Office Action Summary

10/646,929

DETAILED ACTION

FIG. 3

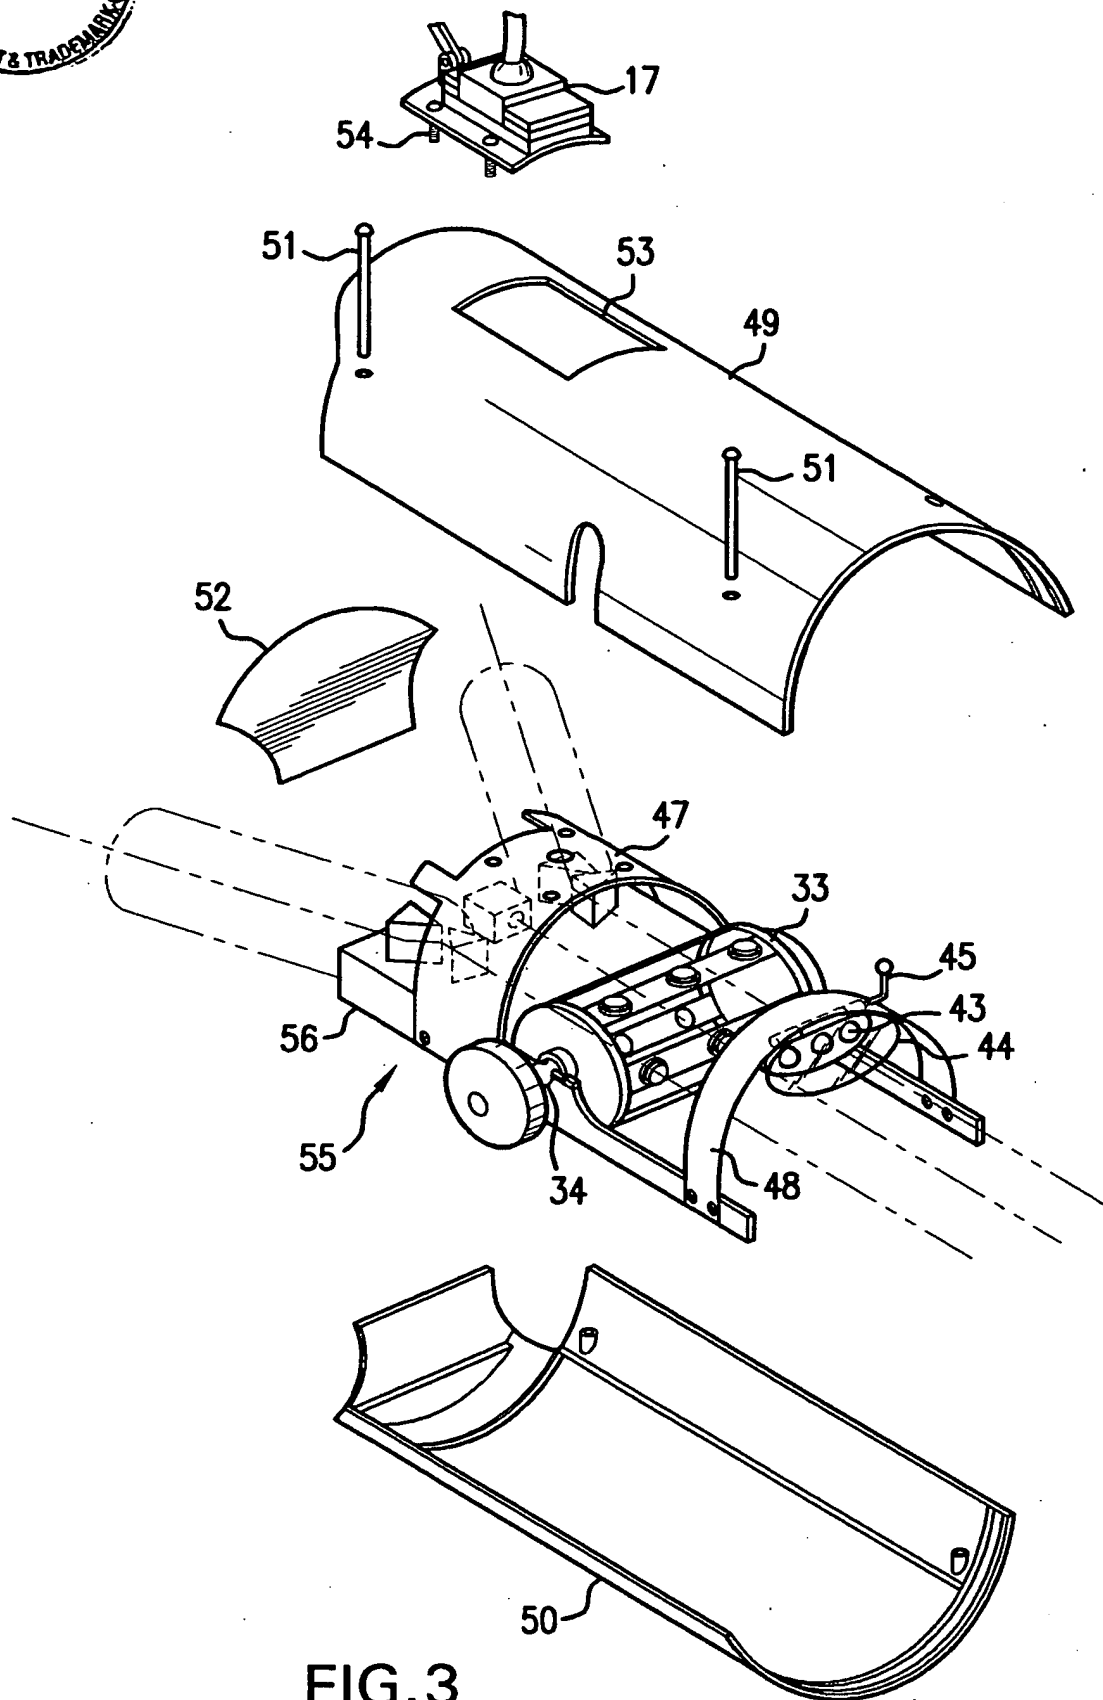
2. The drawing contains corrected figure 3 was received on 4/27/2004 and received one more time on 6/23/05. The corrected figure 3 has been approved by the Examiner.
